PETITION NO. 1425 – Gaylord Mountain Solar Project 2019, LLC	}	Connecticut
petition for a declaratory ruling, pursuant to Connecticut General	}	
Statutes §4-176 and §16-50k, for the proposed construction,	}	Siting
maintenance and operation of a 1.9-megawatt AC solar photovoltaic	}	
electric generating facility located at 360 Gaylord Mountain Road in	}	Council
Hamden, Connecticut, and associated electrical interconnection.	}	
		March 19, 2021

DRAFT Findings of Fact

Figure 4. Proposed site layout of panels on slopes greater than 15/20/30 percent

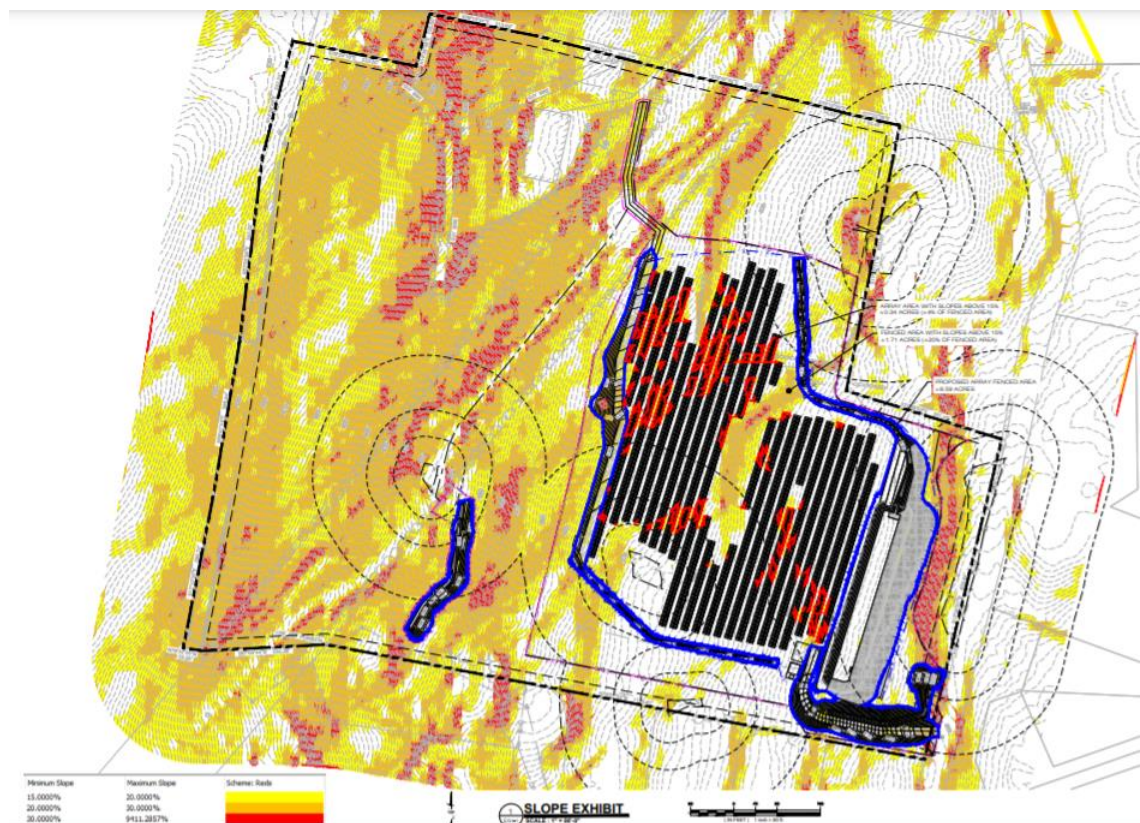
78. Approximately 1.71 acres (or 20 percent) of the 8.6 acre solar field area have slopes greater than 15 percent. Within the solar field, solar panels would be installed on approximately 0.34 acres (or 4 percent) with slopes greater than 15 percent (refer to Figure 4). (GMS 11)

**Figure 5. Proposed concept layout with initial panels oriented due south
layered on top with proposed panels oriented 72.6 degrees east**

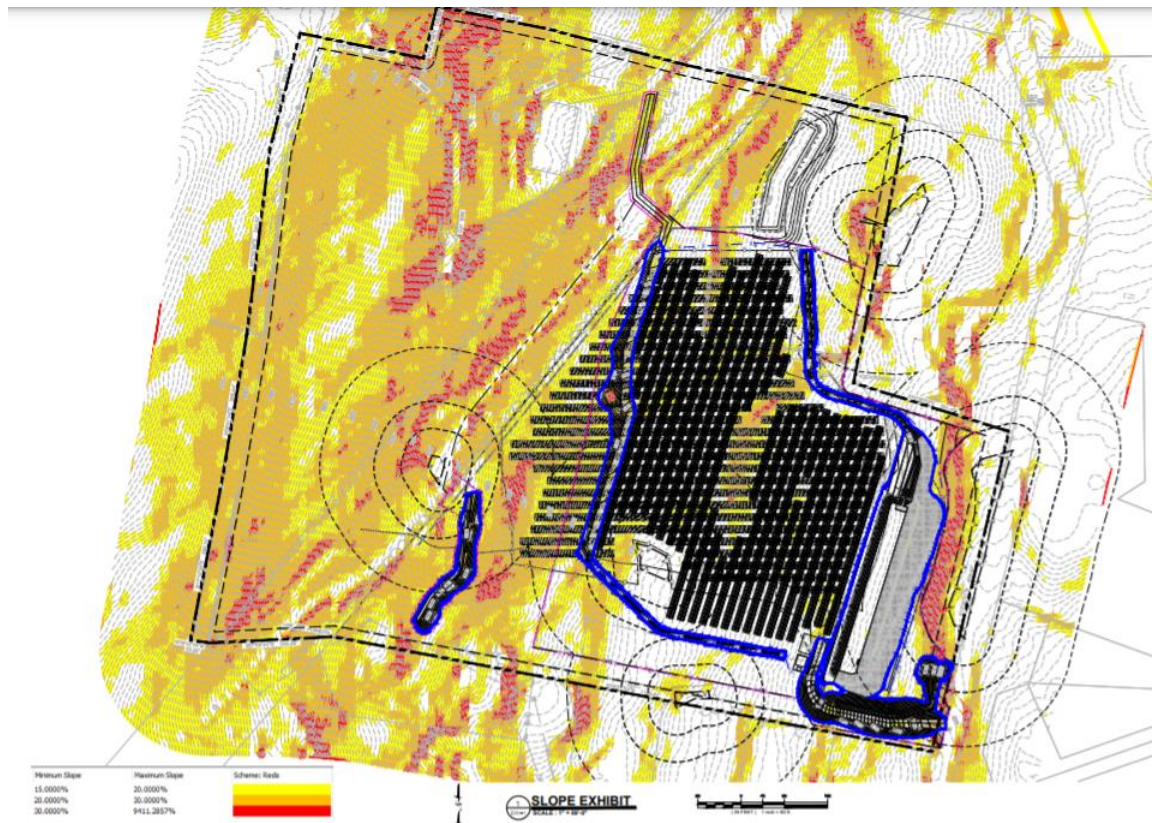
109. The orientation of the solar arrays was modified from facing due south (0 degree azimuth) to face east (72.6 degree azimuth) to reduce the potential for erosion from stormwater running off the panels. This shift in panel orientation resulted in an eight percent reduction of energy production. (GMS 10; Tr. 1, pp. 65-66)
